Access Compliance Report

Public Rights-of-Way

(Curb Ramps)

Intersection ID: 7599	Main Street: LEMS福德_WY	Cross Street: WITHAM_PASSAGE	Location:	SE
ADA ID: DAF83468FDE2	Ramp Type: BlendTrans1	Initial Pass/Fail: Fail	Overall Compliance: No	Severity Score: 25
Codes/Mitigation Info/Possible Solution		Field Measurements/Component Compliance

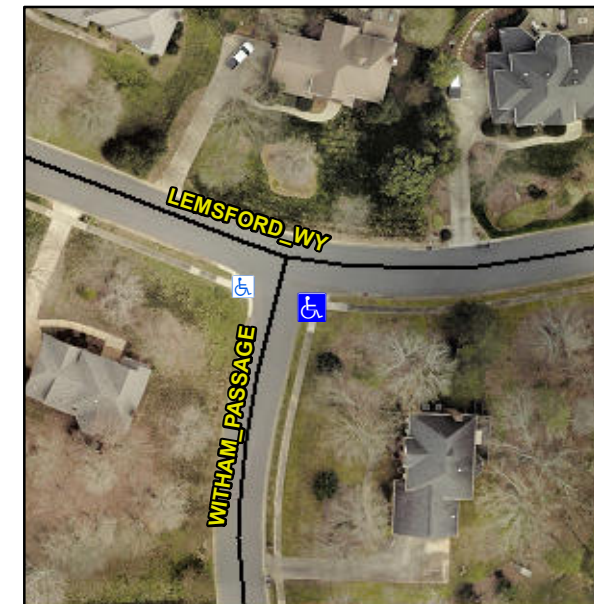
Not Found, R304.5.3

Compliance	Description	Data	Compliance	Description	Data
N/A	Ramp Length (in)	27.0	Yes	BlendTrans Slope (%)	2.9
Yes	Ramp Width (in)	48.0	No	BlendTrans XSlope (%)	8.0
N/A	Flare Type LT	N/A	N/A	Flare Type RT	N/A
N/A	Flare Slope LT (%)	N/A	N/A	Flare Slope RT (%)	N/A
N/A	Flare Traversable LT?	N/A	N/A	Flare Traversable RT?	N/A
N/A	Landing Length (in)	N/A	N/A	DWS Provided?	N/A
N/A	Landing Width (in)	N/A	N/A	DWS Contrast?	N/A
N/A	Landing Slope (%)	N/A	N/A	DWS Length (in)	N/A
N/A	Landing X Slope (%)	N/A	N/A	DWS Full Width?	N/A
N/A	Landing Curb? (Y/N)	N/A	N/A	DWS Offset (in)	N/A
N/A	Shared Landing?	N/A			
N/A	Gutter Ponding?	N/A	N/A	Gutter Slope (%)	N/A
N/A	Gutter Lip Ht (in)	N/A	N/A	Gutter X Slope (%)	N/A
N/A	Painted X Walk1?	No	N/A	Painted X Walk2?	N/A
	X Walk 1 Direction	To NW		X Walk 2 Direction	N/A
	X Walk 1 Width (in)	N/A		X Walk 2 Width (in)	N/A
	X Walk 1 Slope (%)	3.9		X Walk 2 Slope (%)	N/A
	X Walk 1 X Slope (%)	5.7		X Walk 2 X Slope (%)	N/A

N/A	Ramp inside XWalk1?	N/A	N/A	Ramp inside XWalk2?	N/A
	Road Slope (%)	5.7		Clear Space?	N/A
	Road X Slope (%)	3.9	N/A	Clear Space to XWalk (in)	N/A
N/A	Any Obstructions?	N/A	N/A	Storm Grate/Utility Hazard?	N/A
	Obstruction Type			Storm Grate/Utility Type	
		N/A			N/A
			Yes	Surface Condition? (G/P)	Good
			No	Curb Slope (%)	16.7

Remove & Replace Curb Ramp With Two New Directional Ramps or Equivalent.
